DESIGN EVOLUTION

3.3 Pre-Application Meeting 1

A pre-application meeting with Haringey Council took place on 16th August 2022.

Pre-application 1- Proposed site plan

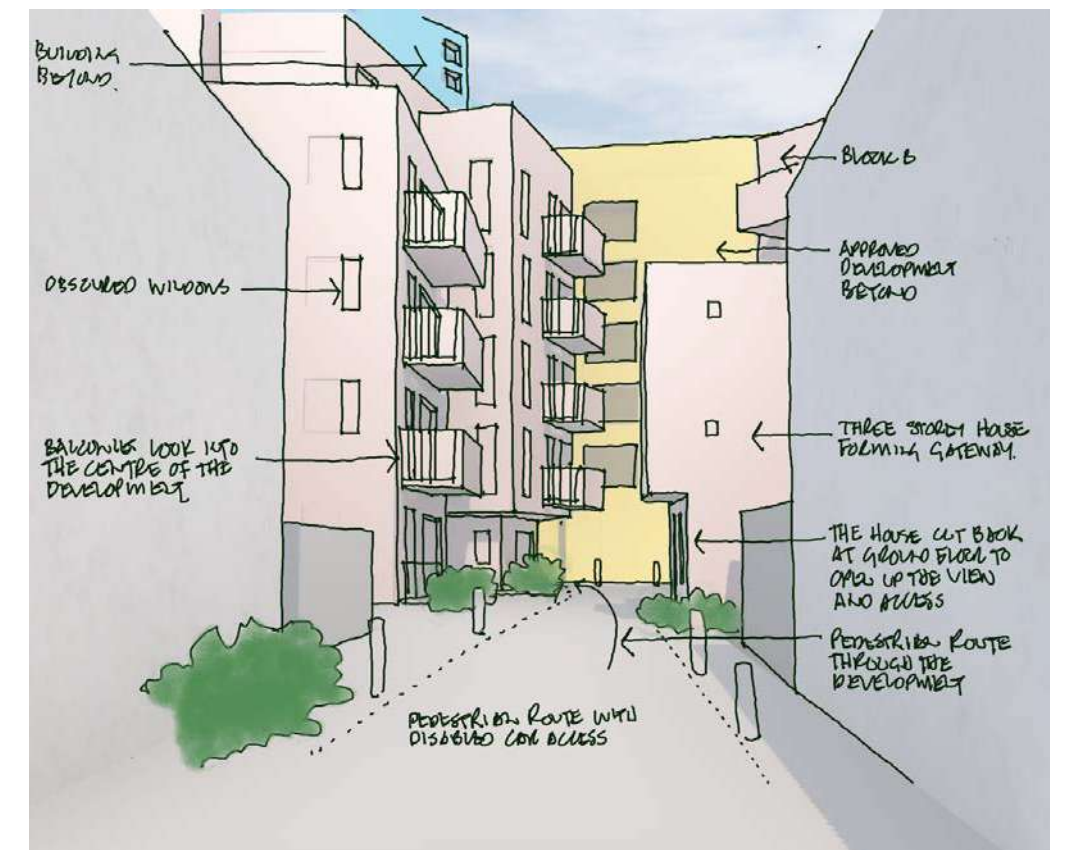
- The site has potential to play an integral role in linking the Haringey Heartlands area to Hornsey Park Road.
- The principle of a mixed-use development aligned with the Council's objectives the residential provision was supported.

- The de-culverting of the Moselle should be investigated in line with policy requirements.
- An indicative masterplan for Site Allocation SA21 illustrating delivery of employment floorspace would be required for future submissions.

- Allocating commercial use at ground floor was advised to provide required street frontage within the site.
- It was advised to review the height of Block A whereas Block B was deemed acceptable.

- The design would be expected to relate to the Clarendon Square development and establish a 'through route' increasing connectivity, permeability and inclusiveness between the low rise and high rise neighborhoods, whilst creating a pocket of public realm.

- Greater visibility through the site from Hornsey Park Road to Brook Road was deemed crucial.
- The proposed unit mix was not fully supported; it was advised to review studios and increase the provision of family units.

- Any proposal would be expected to consider the impact on the amenity of the surrounding properties, particularly the terrace houses on Hornsey Park Road and relevant non-residential uses and future residential developments on adjoining sites.

Pre-application 2- Proposed site plan

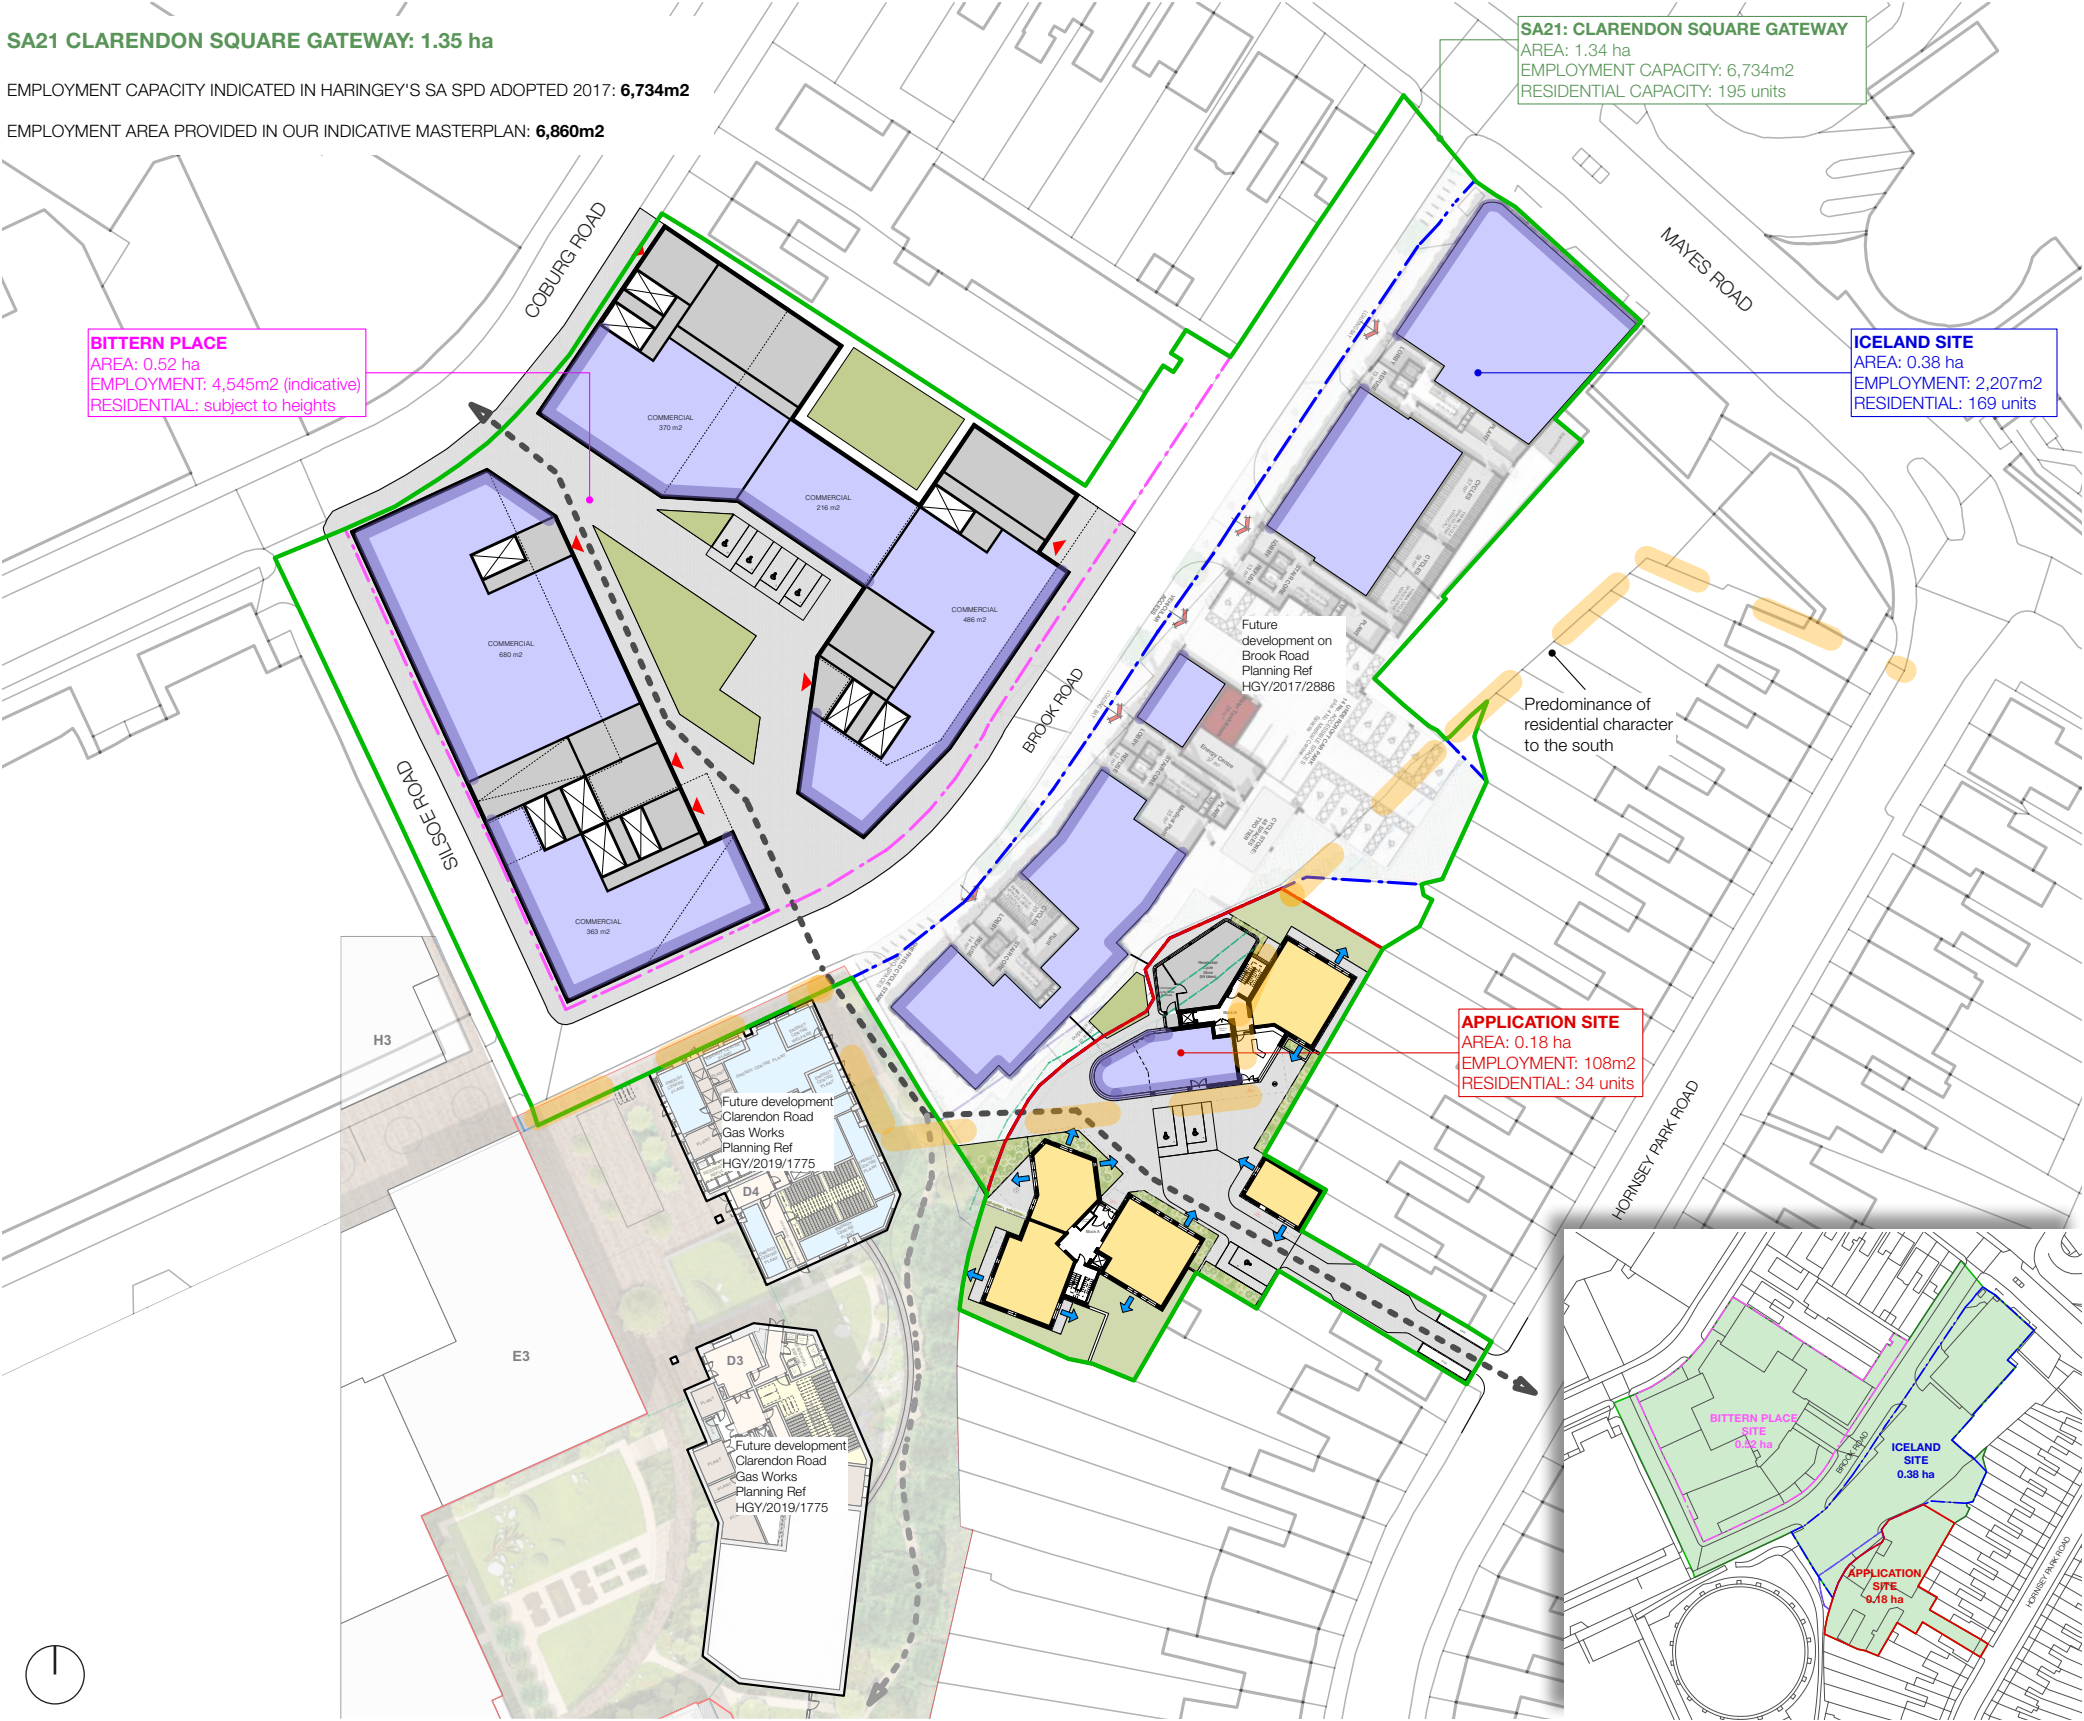
- The Council raised concerns over privacy for the 1bed unit window facing the public space. Reconfiguration or replacement with a duplex unit or commercial use was suggested.

- Differentiation between the private and public space is required; concerns were raised regarding the area north of the commercial unit and next to cycle store. A separate entrance to the cycle store was suggested.

- The proposed route through the site should provide 24h access as the only access route to buildings.
- It was suggested to incorporate play-on-the-way features on open central space formed between Blocks A, B and C, potentially near the entrance to Block B.

- It should be demonstrated that the proposed lay-by is suitable and size appropriate for on-site deliveries.
- If refuse collection is proposed to be on street it requires justification and the Council should be provided with the waiting/ dwell times demonstrating no negative impact on the public highway

- Reference to the Council's Site Allocation DPD - SA21 - Clarendon Square Gateway, which the site is part of, indicates an employment led site capacity.

- It was accepted that the land to the north of Brook Road has more capacity for employment space and is more suitable due to its street frontage.
- It was advised to engage with workspace providers on the strategy for the commercial space and consider 'let-ability' of the commercial unit.

- Proposed heights require justification at a future application.

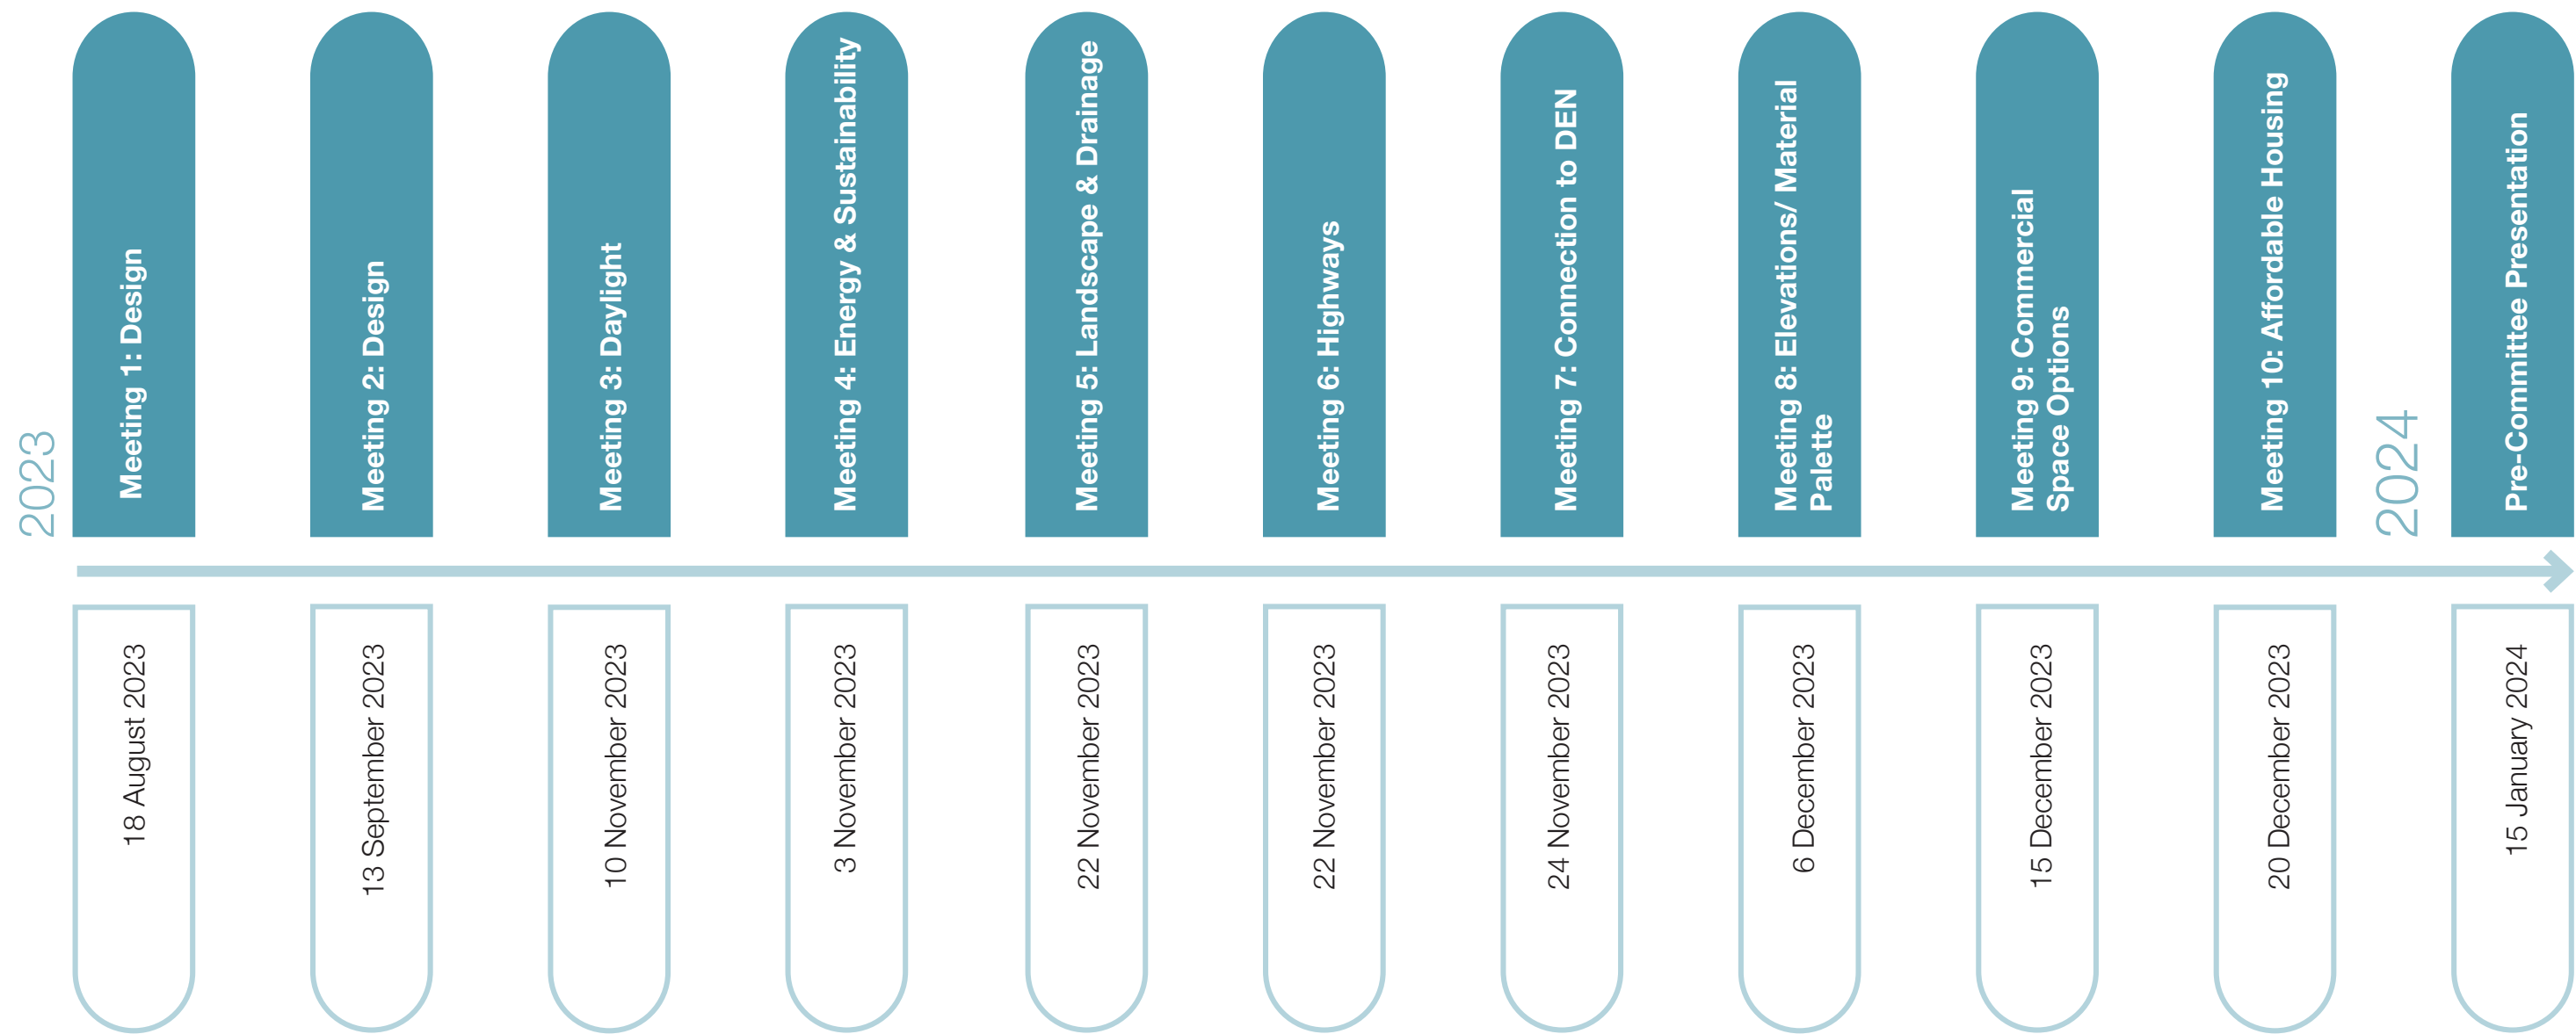
- The panel reiterated its previous concerns regarding the pedestrian route and provision of employment space. However, discussions with the Council have concluded that policy requirements must be delivered and the project team was commended for its work to resolve these challenges.

- It was advised to increase the internal floor-to-ceiling height of the commercial units. Careful consideration should be given to the type of commercial activity.

- The overall proposed scale and massing was supported.
- The panel was particularly concerned about the lack of separation between vehicles and pedestrians. It was suggested that vehicles are only allowed up to the western corner of the commercial block, with a clear stop and a turning head. The public realm beyond that point could be pedestrian friendly with soft landscaping.

- Clear distinction between public, private, or semi-private areas on landscape plan, alongside a realistic management strategy for maintaining the proposed spaces.

- Careful consideration should be given on surface materials changes and boundary treatments to clarify the nature of different space types for occupants and for visitors.

- The panel raised concerns that the circular plant room (drum) is likely to cause antisocial behaviour problems and undermine safety by allowing for unobserved loitering. It was recommended to incorporate it inside the buildings and turn that area into a larger play space that would be overlooked, south-facing, and easier to manage.

- The removal of bins lining the access road was a welcomed improvement to the entrance.
- The revision to allow for a wider pedestrian pavement to one side of the public realm entrance route was welcomed as more inclusive than narrower pavements on both sides.

- A lighting strategy that suffice for safety and security without disturbing the residents was considered crucial for the public realm.
